**Addendum
No. 2**

Addendum Date: April 15, 2020

Project: Wilmington Manor E.S. – Boiler Replacement

BOILER SHUT-OFF CONTROL DIAGRAM REV

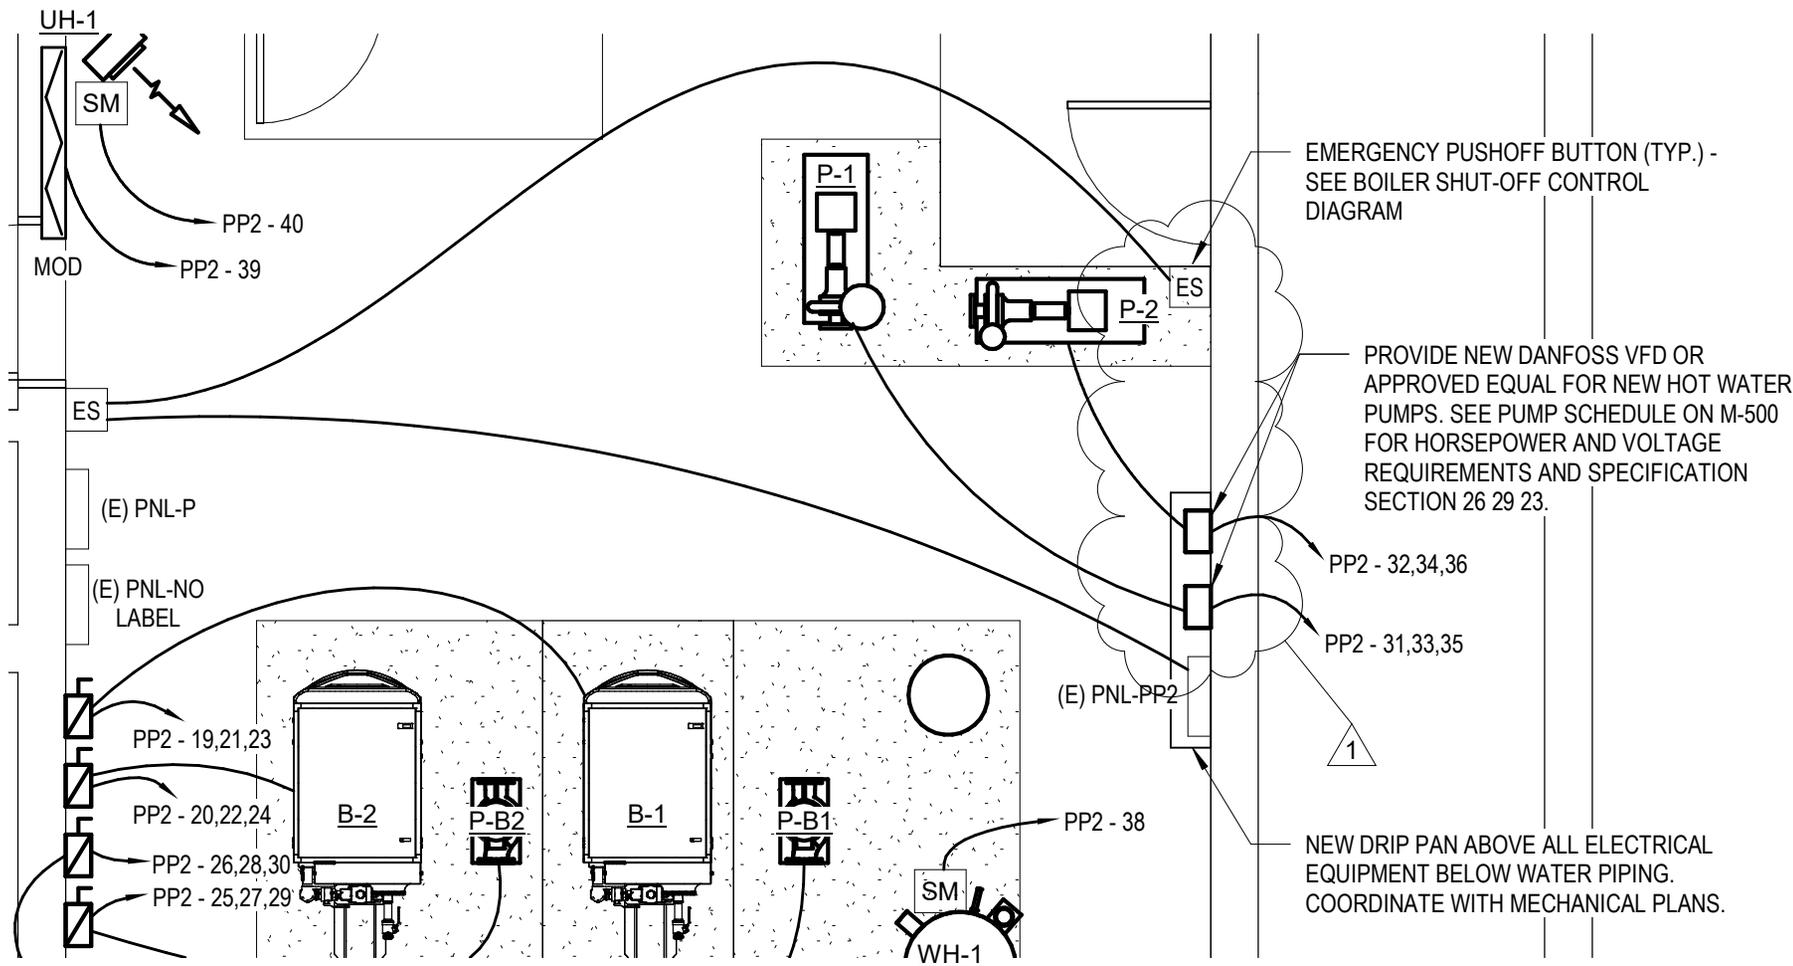
1. Drawing M000 – Mechanical Cover Sheet: Changes to the drawing shall be as follows:
 - a. DELETE GENERAL NOTE #16: Replacement of heating-only valves has been removed from the scope of the project.
2. Drawing E-101 – Electrical Plans: Changes to the drawing shall be as follows:
 - a. Deleted boiler shutoff contactor. Emergency shutoff buttons to be connected to the shunt trip coil of the boiler circuit breakers. See sketches SK-E.1 and SK-E.2.
